### **TURKEY POINT NUCLEAR GENERATING STATION UNIT 3 AND UNIT 4**

#### **IMPROVED TECHNICAL SPECIFICATIONS CONVERSION**

##### **ITS SECTION 3.1 REACTIVITY CONTROL SYSTEMS**

**Revision 1**

Figure 3.1.3-1 (page 1 of 1)  
Moderator Temperature Coefficient Vs. Rated Thermal Power

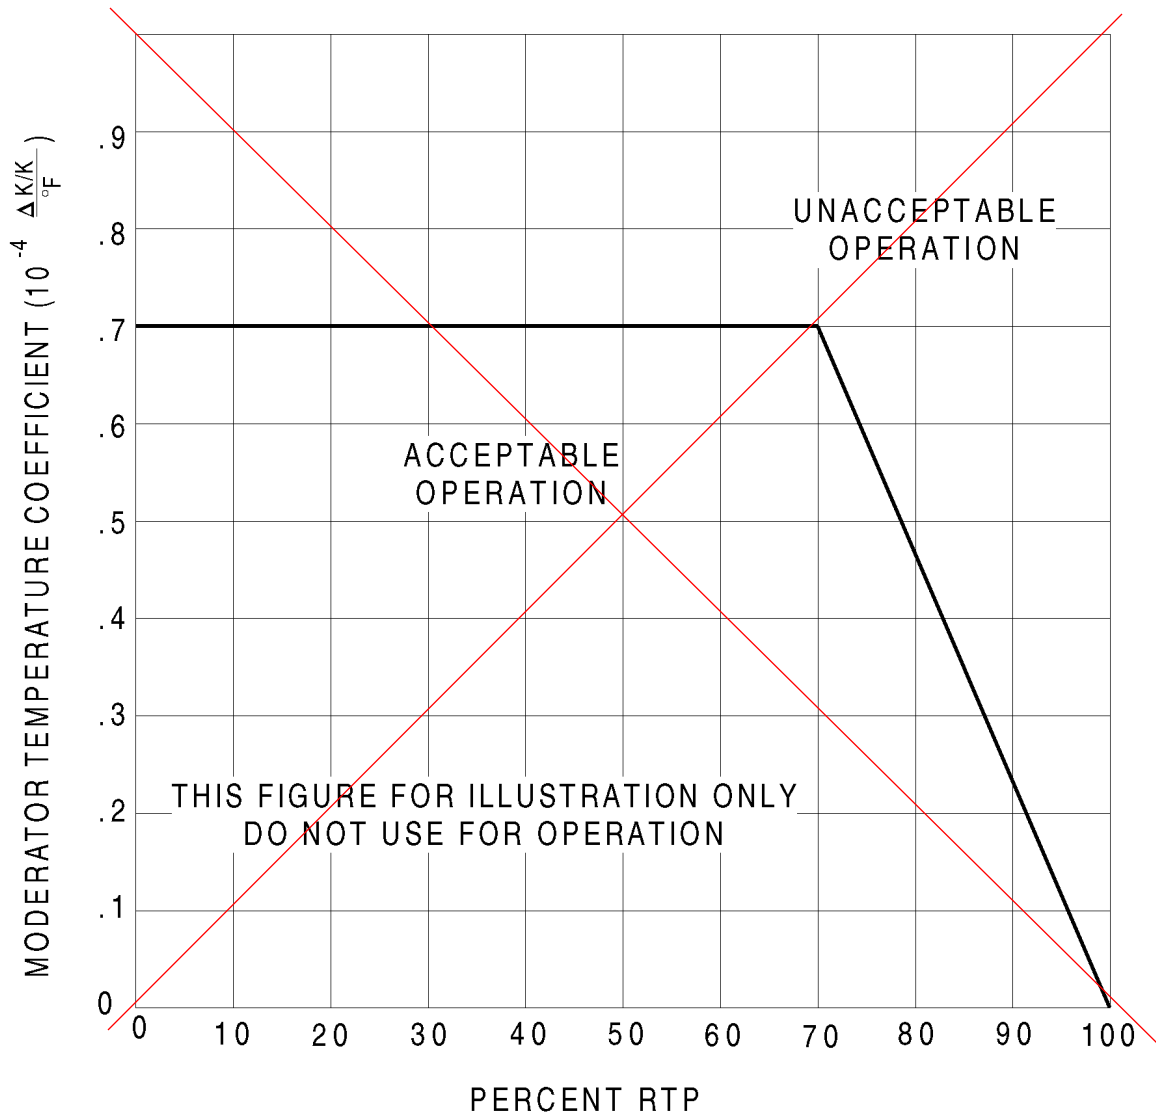
1. The Improved Standard Technical Specifications (ISTS) contains bracketed information and/or values that are generic to Westinghouse vintage plants. The brackets are removed and the proper plant specific information/value is inserted to reflect the current licensing basis.
2. Changes are made (additions, deletions, and/or changes) to the ISTS that reflect the plant specific nomenclature, number, reference, system description, analysis, or licensing basis description.
3. ISTS 3.1.3 contains Figure 3.1.3-1 for Moderator Temperature Coefficient Vs Rated Thermal Power. This figure is not maintained in ITS 3.1.3. ITS 3.1.3 lists the maximum upper limit value in the LCO. Therefore, ISTS Figure 3.1.3-1 is not required and has been deleted.
4. Changes are made to be consistent with Specification.

Figure B 3.1.6 (page 1 of 1)  
Control Bank Insertion vs. Percent RTP

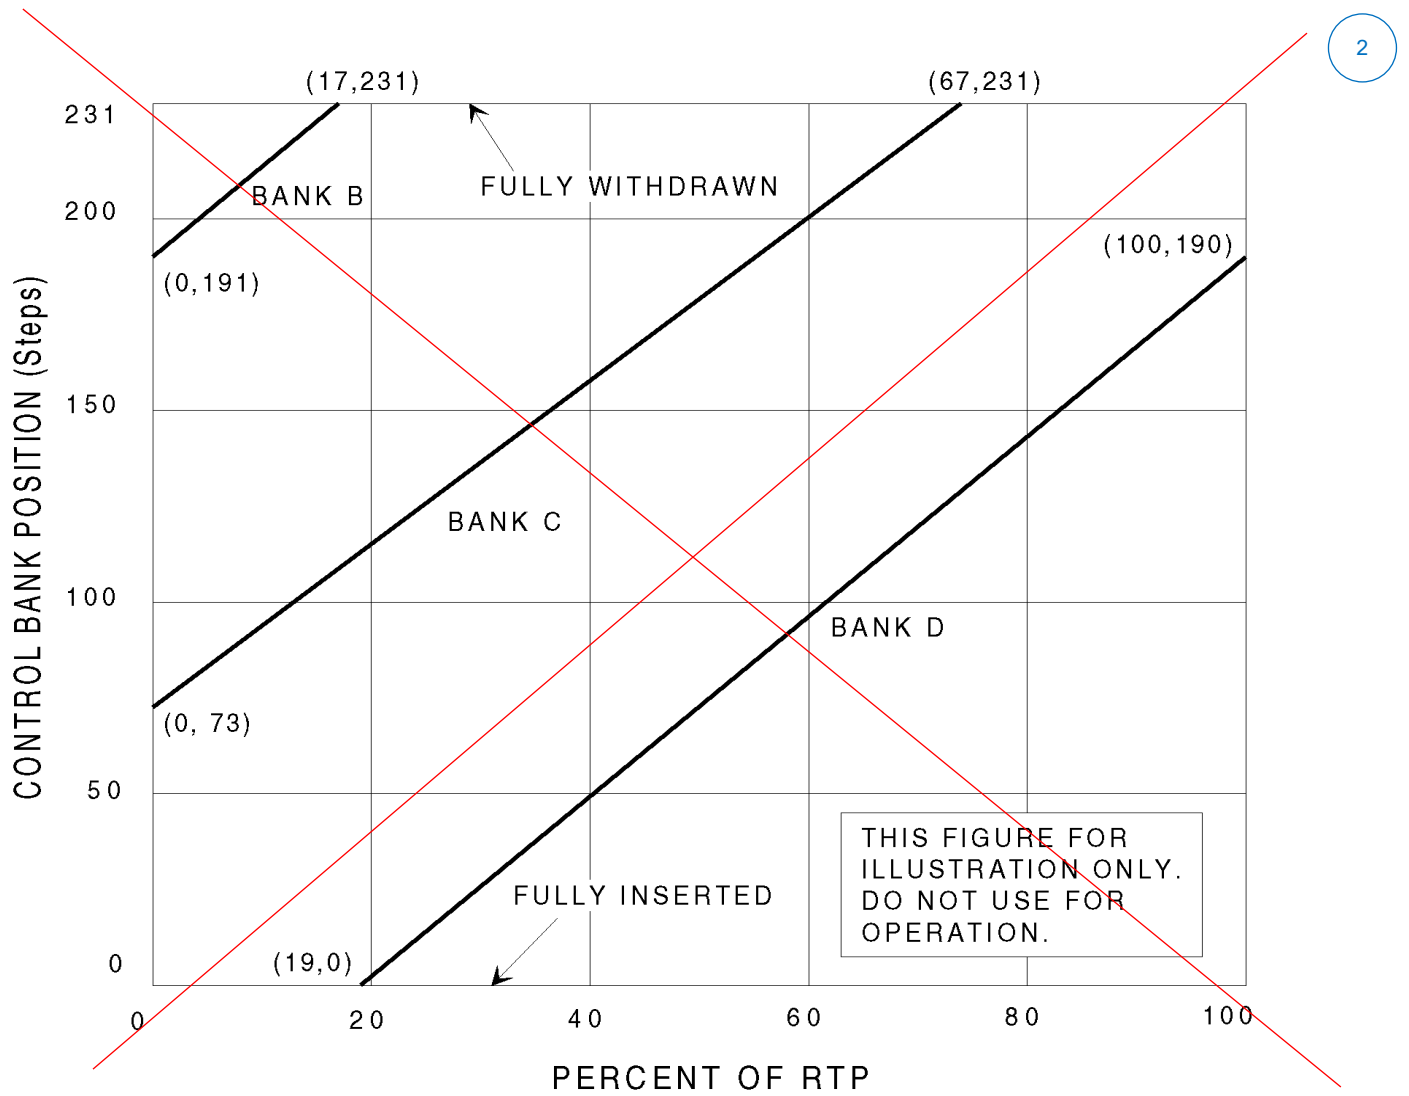
2. ISTS 3.1.6 contains Figure B 3.1.6-1 and states that it is an example provided for information only. Turkey Point Nuclear Generating Station (PTN) Improved Technical Specification (ITS) 3.1.6 does not include Figure B 3.1.6-1. The control bank insertion limits for PTN are located in the Core Operating Limits Report (COLR). Therefore, ISTS Figure B 3.1.6-1 and the references to the ISTS Figure B 3.1.6-1 have been deleted.

Figure 3.1-2  
BORIC ACID TANK MINIMUM VOLUME (1)  
Modes 1, 2, 3 and 4

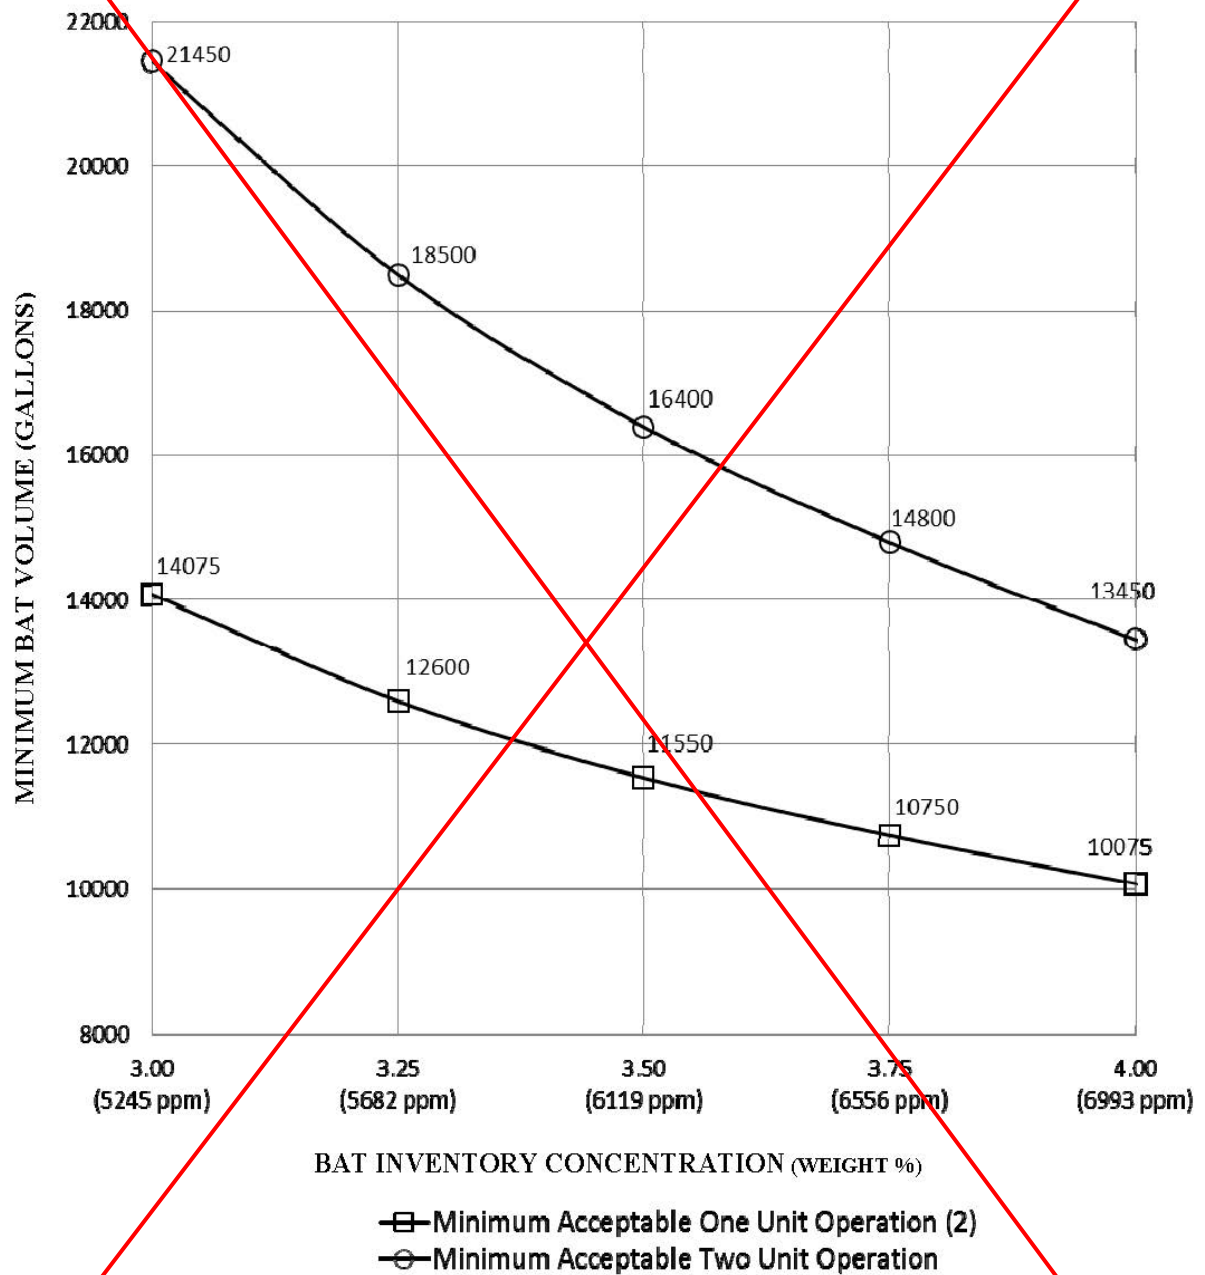
- a. ~~— A Boric Acid Storage System with:~~
  - 1) ~~— A minimum indicated borated water volume in accordance with Figure 3.1-2,~~
  - 2) ~~— A boron concentration in accordance with Figure 3.1-2, and~~
  - 3) ~~— A minimum boric acid tanks room temperature of 62°F.~~
- b. ~~— The refueling water storage tank (RWST) with:~~
  - 1) ~~— A minimum indicated borated water volume of 320,000 gallons,~~
  - 2) ~~— A boron concentration between 2400 ppm and 2600 ppm.~~
  - 3) ~~— A minimum solution temperature of 39°F, and~~
  - 4) ~~— A maximum solution temperature of 100°F.~~
